1

PRE-APPLICATION CONFERENCE
NW 9th Ave Subdivision & Rezone (2025-013-PAC)

COMMENTS TO 9TH AVENUE SUBDIVISION

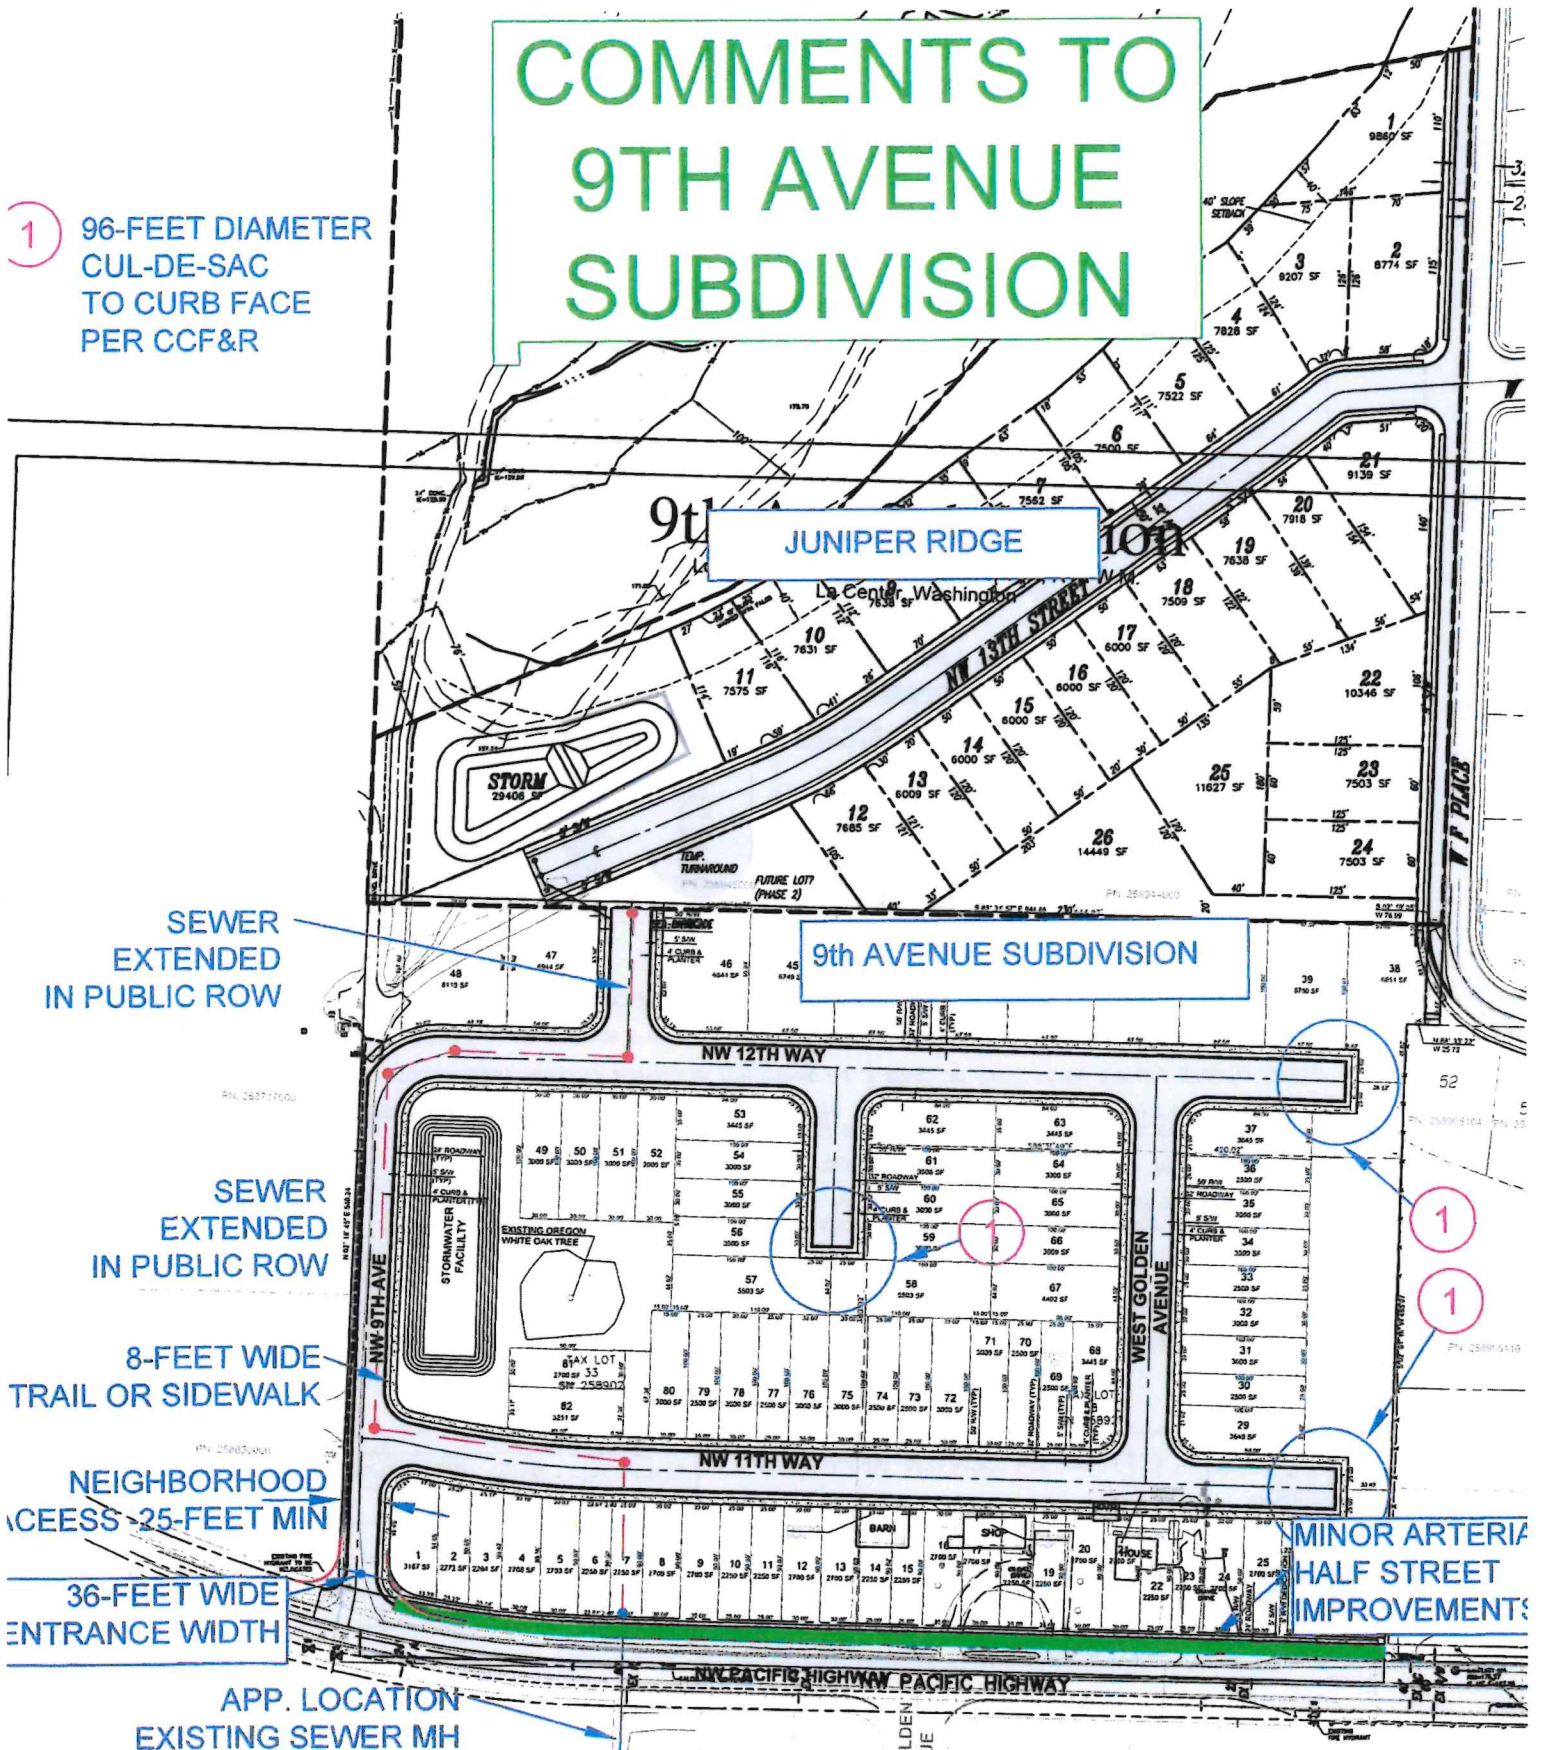
The unnamed street stub south of NW 12th Way will serve 10 lots. In addition, the east end of NW 12th Way and NW 11th Way, shows a street stub with no turnaround, serving several lots. Per the Engineering Standards, a cul-de-sac is required. The width shall be minimum of a 96-foot diameter cul-de-sac from curb to curb, and 108-feet ROW per city and CCF&R standard.

① 96-FOOT DIAMETER
CUL-DE-SAC
TO CURB FACE
PER CCF&R

SEWER
EXTENDED
IN PUBLIC ROW

SEWER
EXTENDED
IN PUBLIC ROW

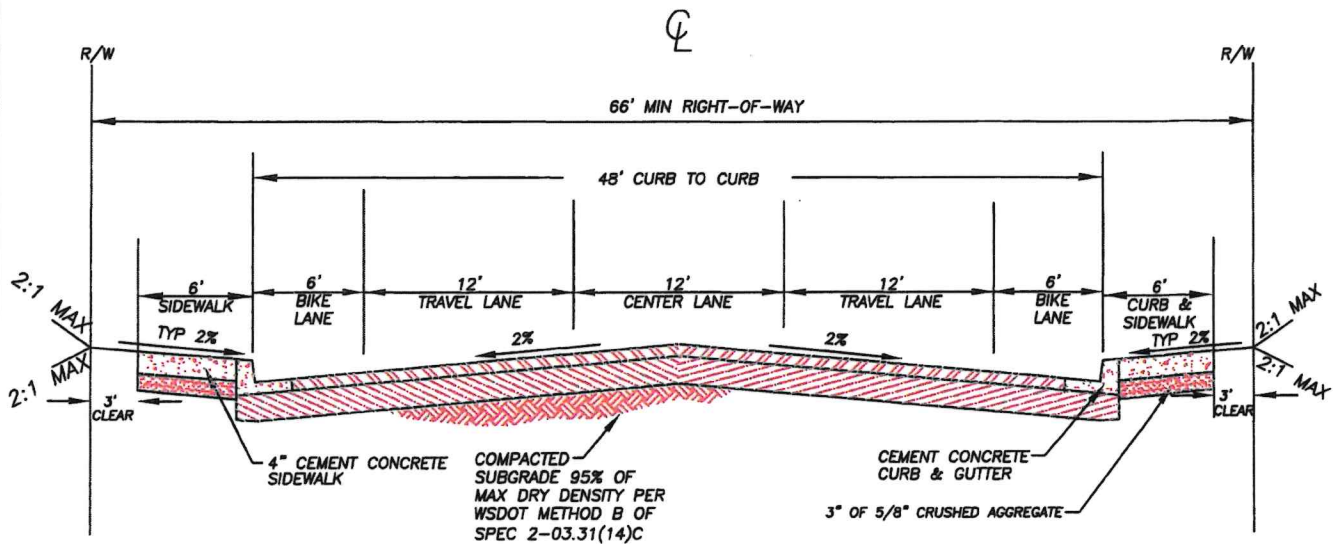
The applicant will need to dedicate right of way or an easement for an 8-foot wide trail along this corridor. A concrete sidewalk adjacent to 9th Avenue will be acceptable. The trail or sidewalk will need to connect to Pacific Highway, via 9th Street public right of way. See the park plan map.

8-FOOT WIDE
TRAIL OR SIDEWALK

NEIGHBORHOOD
ACCESS - 25-FEET MIN

36-FOOT WIDE
ENTRANCE WIDTH

APP. LOCATION
EXISTING SEWER MH

MINOR ARTERIAL
HALF STREET
IMPROVEMENTS
